U.S. Department of the Interior
BUREAU OF LAND MANAGEMENT

Notice of Intent

Type of Action: Plug and Abandonment

CONDITIONS OF APPROVAL

Planned P & A Wellbore Schematic

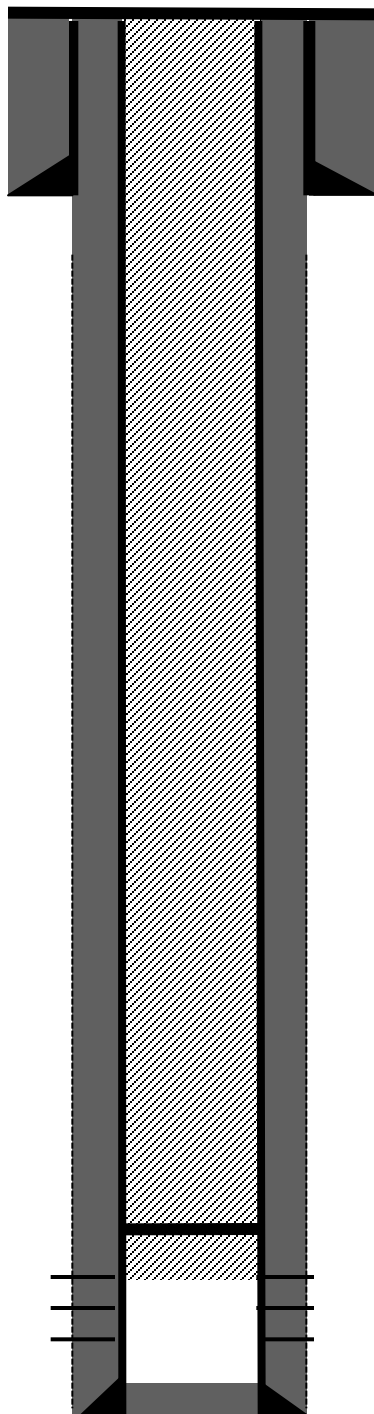
1. Plugging operations authorized are subject to the attached "General Requirements for Permanent Abandonment of Wells on Federal and Indian Lease."
2. The following modifications to your plugging program are to be made:
 - a. Complete wellbore fill up. No changes to the procedure.
3. **Notification:** Farmington Office is to be notified at least 24 hours before the plugging operations commence at (505) 564 7750.

You are also required to place cement excesses per 4.2 and 4.4 of the attached General Requirements.
